**ZONING AMENDMENT,  
PLANNED UNIT DEVELOPMENT &  
SUBDIVISION STAFF REPORT**

**Date: June 5, 2014**

<b><u>NAME</u></b>	Don Williams
<b><u>SUBDIVISION NAME</u></b>	La Belle Subdivision, Re-subdivision and Addition to Lot 1
<b><u>LOCATION</u></b>	5951 & 5955 Old Shell Road and 14 East Drive (Southwest corner of Old Shell Road and East Drive)
<b><u>CITY COUNCIL DISTRICT</u></b>	District 6
<b><u>CURRENT ZONING</u></b>	R-1, Single-Family Residential District, and B-2, Neighborhood Business District
<b><u>PROPOSED ZONING</u></b>	B-2, Neighborhood Business District
<b><u>REASON FOR REZONING</u></b>	Subdivision of land, and resolution of a split-zoning issue created by the proposed Subdivision.
<b><u>AREA OF PROPERTY</u></b>	1 Lots / 1.4± Acres
<b><u>CONTEMPLATED USE</u></b>	<p>Subdivision approval to create 1 legal lot of record, Planned Unit Development Approval to allow multiple buildings on a single building site and shared access between two building sites, and Rezoning from R-1, Single-Family Residential District, and B-2, Neighborhood Business District, to B-2, Neighborhood Business District to eliminate split zoning in a proposed Subdivision and allow construction of a parking l

# SITE PLAN

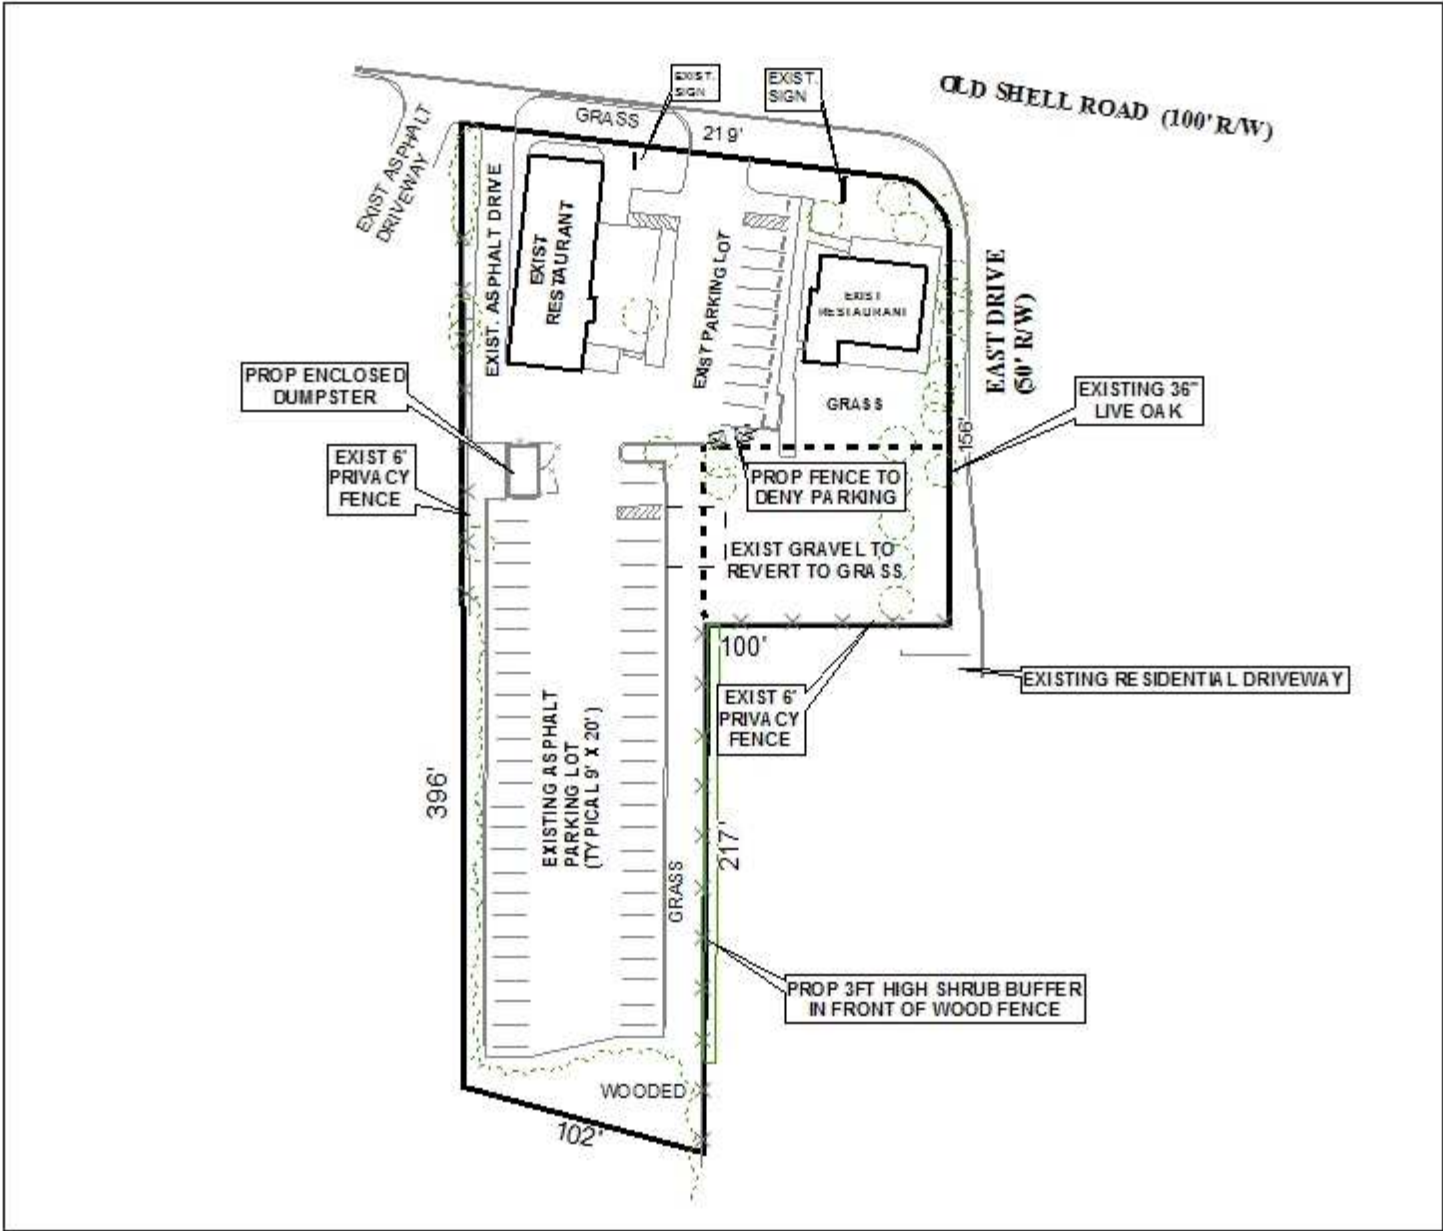
The applicant proposes to develop the residentially-zoned portion of the site to include paved parking, trees, landscaping and an additional entrance for the development from East Drive. Currently, the site does not have access to East Drive, thus all traffic associated with the restaurants enters and exits the site via curb-cuts onto Old Shell Road. Access to East Drive will afford access to and from Old Shell Road via an intersection with a traffic signal. As designed, however, the curb-cut to East Drive will be angled, creating an awkward turning angle for vehicles entering the site from southbound East Drive. It should be noted that a large oak tree in the proximity of the proposed curb-cut is the reason for the proposed design.

As a new curb-cut is proposed onto East Drive, staff recommends that the existing one-lane wide driveway on the West side of site be eliminated. The paving should be removed along the entire length abutting the Picklefish restaurant, the area landscaped, and curbing added to prevent access from Old Shell Road or from the existing parking lot.

Access to the new parking area from the existing parking area will be via a 24-foot wide driveway that will extend between two existing parking spaces. As no curbing or radius is provided for the driveway, cars parked in the existing parking spaces will likely be at high risk for damage by other vehicles, including delivery trucks, which will inevitably choose to enter or exit via the East Drive curb-cut. Staff recommends that the two abutting parking spaces be eliminated and replaced with curbed planting islands.

A sidewalk along East Drive is not depicted where the new parking area is proposed. As the site is commercial, a sidewalk waiver request must be submitted to the Planning Commission for consideration, or a sidewalk must be provided.

The existing dumpsters do not meet the 10-foot setback requirement for commercial sites abutting residentially zoned properties. While an appropriate dumpster enclosure is proposed, there appears to be sufficient room to relocate the dumpsters and the proposed enclosure to meet all setback requirements. Relocation of dumpsters will require sanitary sewer connections.

Finally, there was an unpermitted addition to the Picklefish building after the initial PUD approval in 2011, and it is not reflected on the submitted site plan.

*The revised site plan illustrates the removal of the previously proposed additional parking off of East Drive, with a note stating that the existing gravel surfacing will be allowed to revert to grass. Along East Drive where the previously proposed curb cut was located, the existing fence is illustrated as being removed, and five live oak trees are proposed to be planted where the existing fence is currently located. There is also grass, a railroad tie bumper stop, and a 3' high privacy fence illustrated where the internal curb cut to the previously proposed parking addition was located. The applicant has also revised the site plan to illustrate proposed 36-inch high shrubs along the existing 6-foot high privacy fence along the rear of the residential properties on East Drive to better shield car headlights.*

*A previous condition of approval was the removal of the curb cut and drive on the West side of the existing Picklefish restaurant. While the revised site plan illustrates this drive as remaining, a proposed "Service Entrance Only" sign is depicted.*

*As previously mentioned, there was an unpermitted structure at the rear of the Picklefish building. The revised site plan has a note stating that this unpermitted structure will be removed. A demolition permit should be obtained prior to the removal of this structure.*

*Another issue of concern previously noted is that the dumpsters were illustrated within the 10-foot residential buffer. The dumpster location has been changed to illustrate them 15-feet away from the property line, connected to sanitary sewer, and with an appropriate dumpster enclosure.*

- 2) the site is limited to the fencing, landscaping, and tree plantings as depicted on the revised Planned Unit Development site plan;*
- 3) compliance with revised Traffic Engineering comments: "The site plan has been revised to eliminate the curb-cut to East Dr. Site is limited to the existing curb cuts, with size, location and design to be approved by Traffic Engineering and conform to AASHTO standards. All new on-site parking, including ADA handicap spaces, shall meet the minimum standards as defined in Section 64-6 of the City's Zoning Ordinance.";*
